United Nations ECE/ADN/45

European Agreement concerning the International Carriage of Dangerous Goods by Inland Waterways (ADN)

Draft amendments to the Regulations annexed to ADN*

Classification of zones for tank vessels

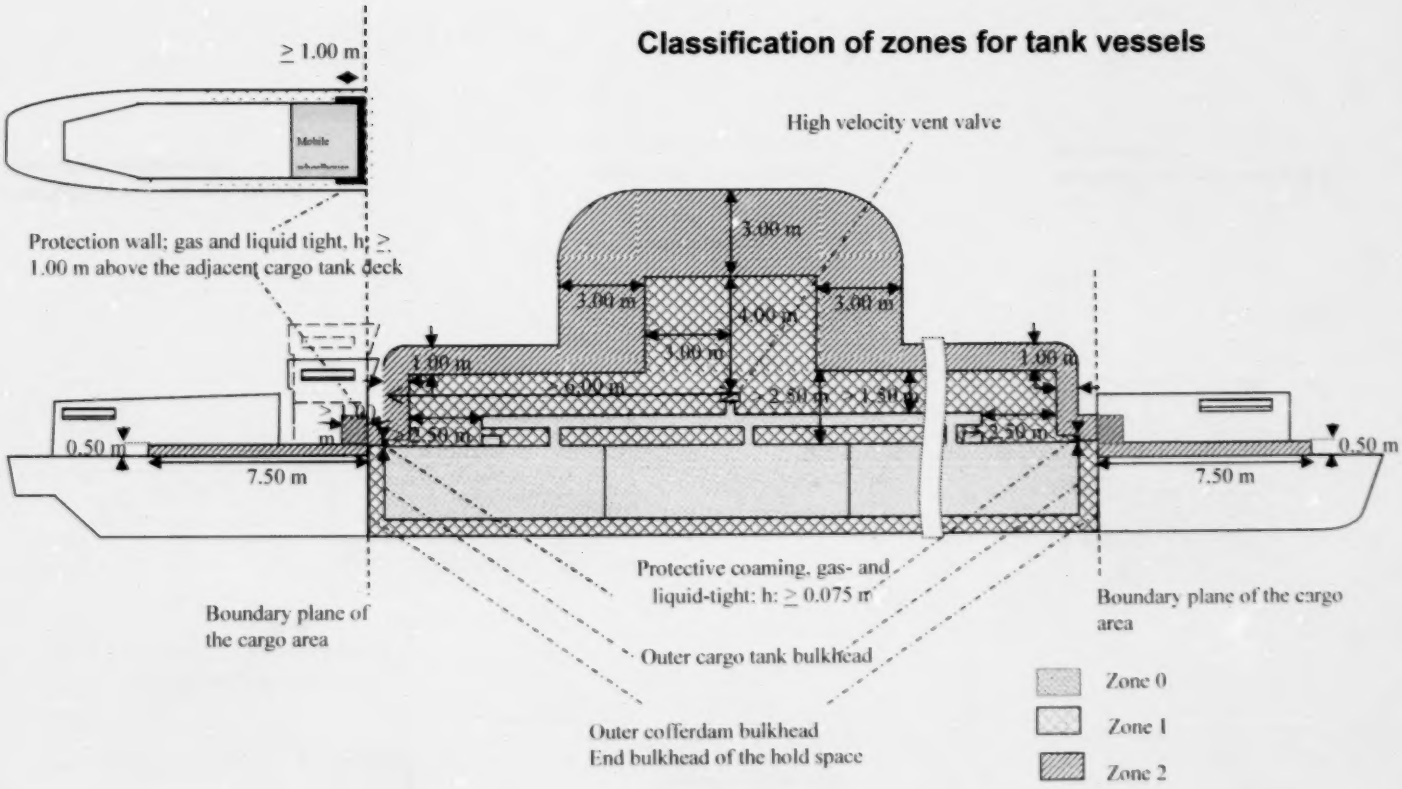
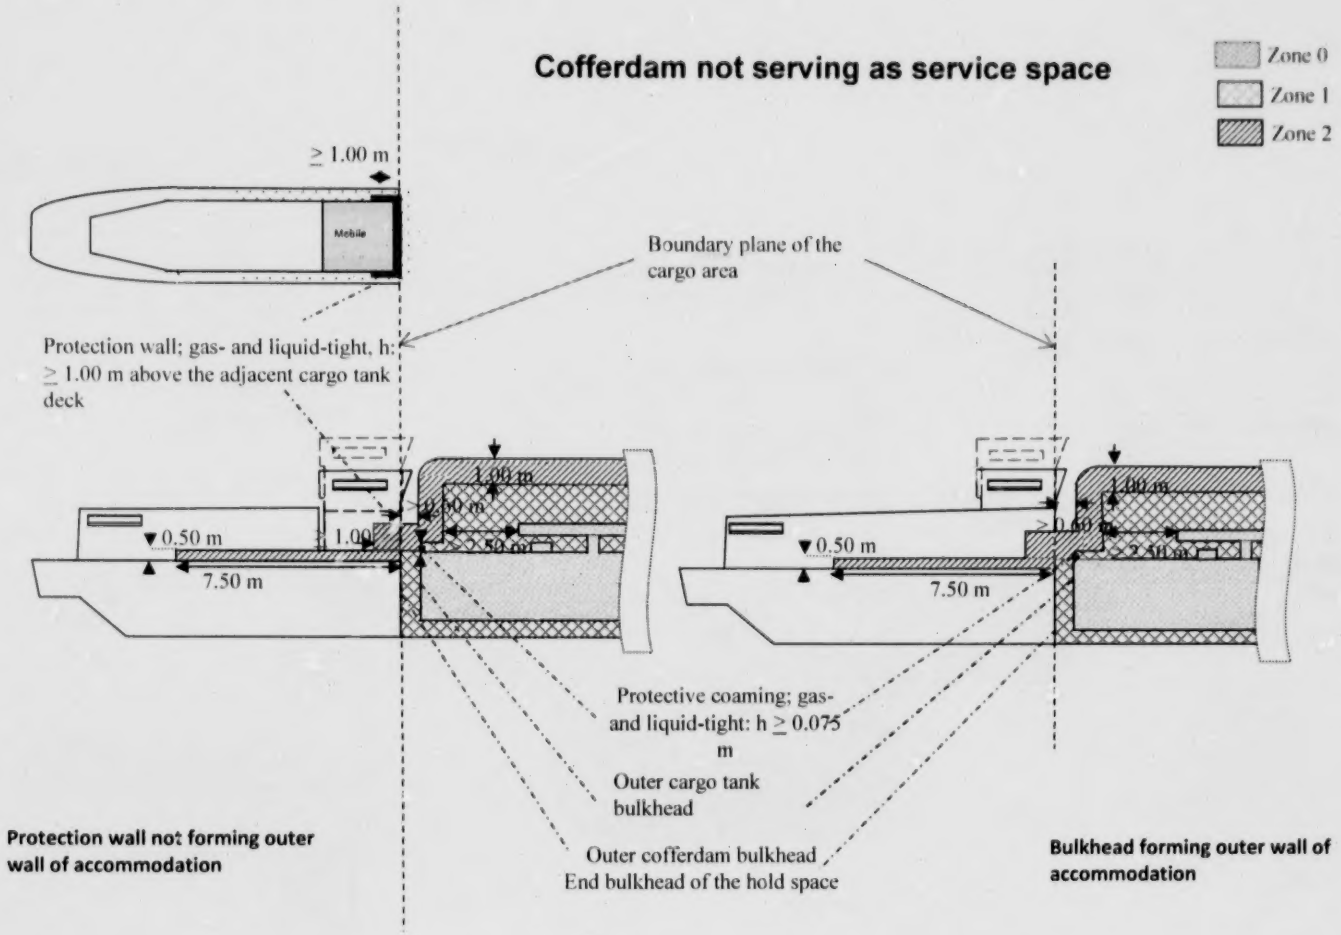
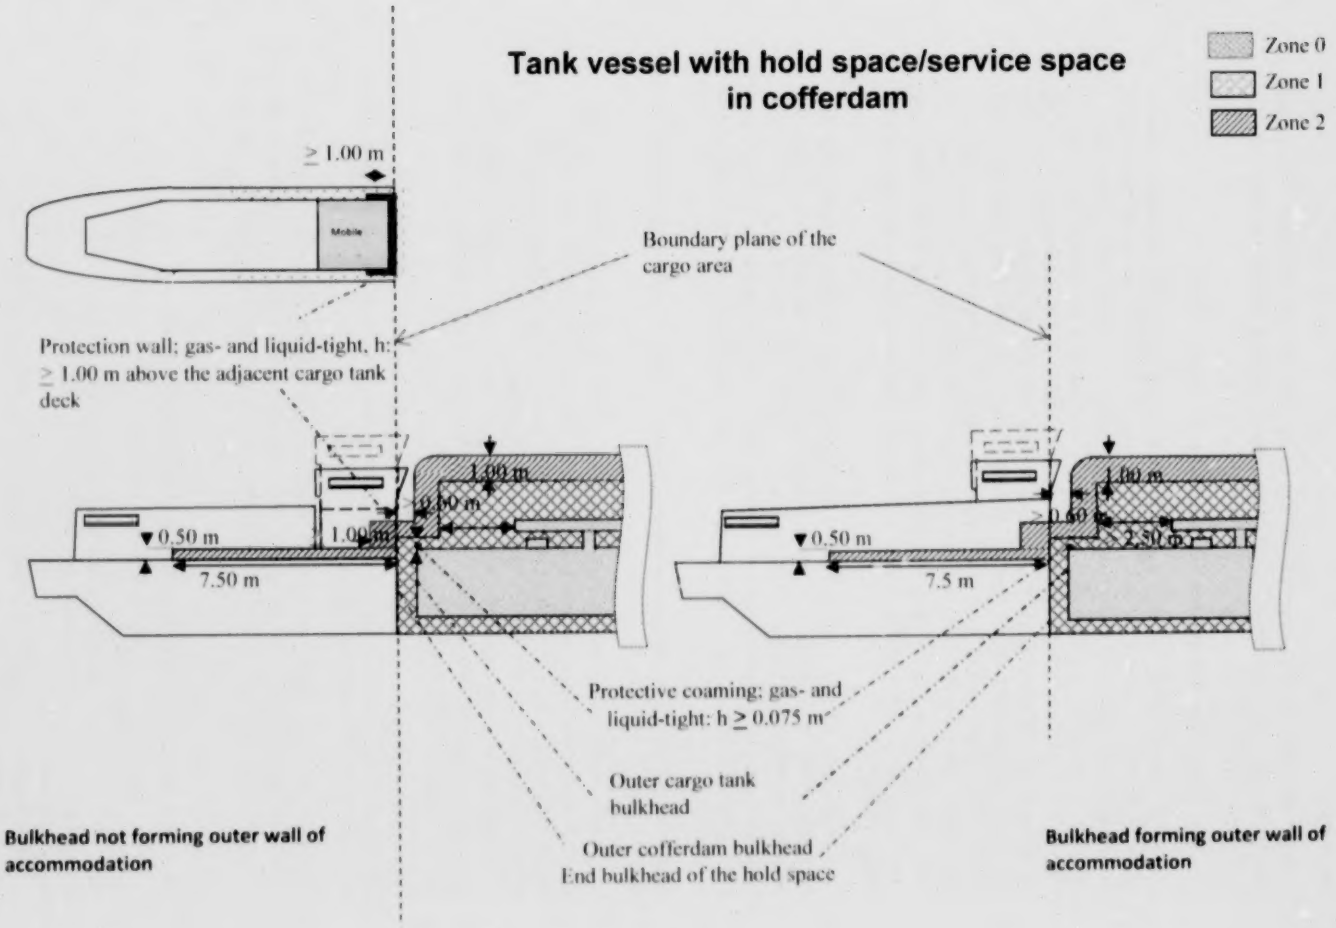
- All spaces located below deck in the cargo area not part of zone 0.
- Closed spaces on deck within the cargo area.
- The deck in the cargo area over the entire width of the vessel to the outer cofferdam bulkheads.
- Up to a distance of at least 1.60 m to the "boundary planes of the cargo area", the height above the deck is 2.50 m, but at least 1.50 m above the highest piping carrying cargoes or cargo vapours.

If the ship is built with hold spaces or a cofferdam/part of a cofferdam is arranged as a service space, the adjacent height (fore and aft) to the "boundary plane of the cargo area" is 1.00 m above deck (see diagram).
- Every opening in zone 0 except the high velocity vent valves/safety valves of pressurized cargo tanks shall be surrounded by a cylindrical zone 1 having at least a width of 2.50 m. With openings of which the diameter is less than 0.026 m (1"), the distance to the outer

- On the deck in the cargo area, a zone extending 1.00 m upwards and sidewards longitudinally from zone 1.
- On the fore deck and the aft deck, an area 7.50 m in length across the entire width of the vessel and adjacent to the "boundary plane of the cargo area". Between the lateral side of the vessel and the protection wall, the length and height of this area equals the dimensions of the lateral side of the protection wall. Elsewhere, the height in zone 2 is 0.50 m.

This area is not part of zone 2 if the protection wall extends from one side of the vessel to the other and there are no openings.
- An area of 3.00 m extending around zone 1 encompassing the high velocity vent valves/safety valves of pressure cargo tanks.
- Around the ventilation inlets of service spaces fitted with a ventilation system located in the cargo area, a zone included in a hemispherical shell with a radius of 1.00 m extending around zone 1;".

Figure 2.2.8.1.6.1: Step-wise approach to classify and assign packing group of corrosive mixtures

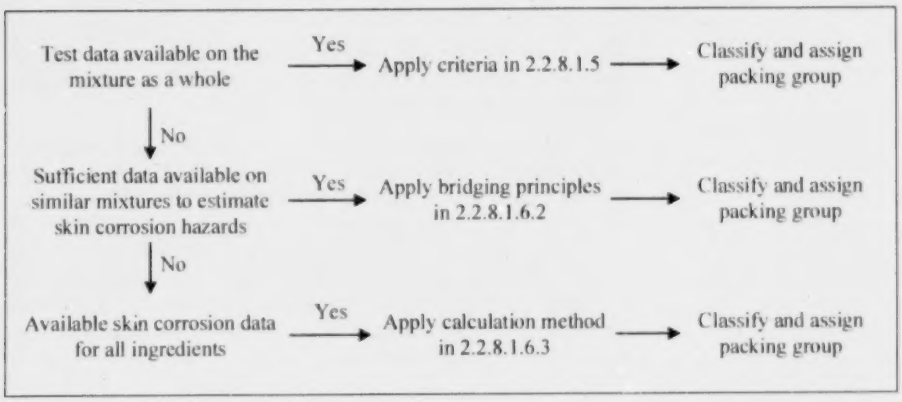
For mixtures it is necessary to obtain or derive information that allows the criteria to be applied to the mixture for the purpose of classification and assignment of packing groups. The approach to classification and assignment of packing groups is tiered, and is dependent upon the amount of information available for the mixture itself, for similar mixtures and/or for its ingredients. The flow chart of Figure 2.2.8.1.6.1 below outlines the process to be followed:

Figure 2.2.8.1.6.3: Calculation method

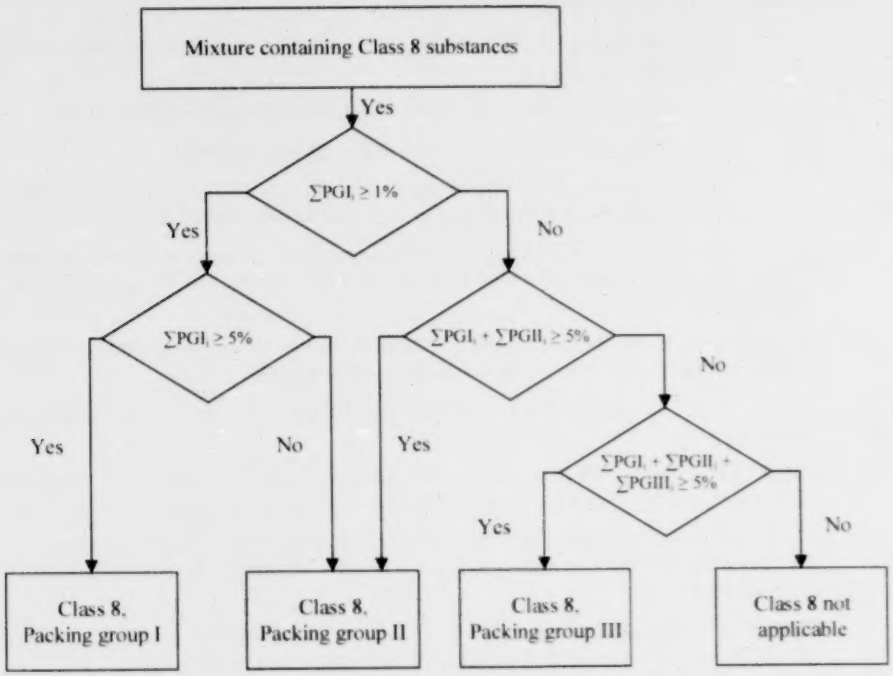
2.2.8.1.6.3.3 To determine whether a mixture containing corrosive substances shall be considered a corrosive mixture and to assign a packing group, the calculation method in the flow chart in Figure 2.2.8.1.6.3 shall be applied.

The criterion for a packing group is fulfilled when the result of the calculation is ≥ 1. The generic concentration limits to be used for the evaluation in each step of the calculation method are those found in Figure 2.2.8.1.6.3.
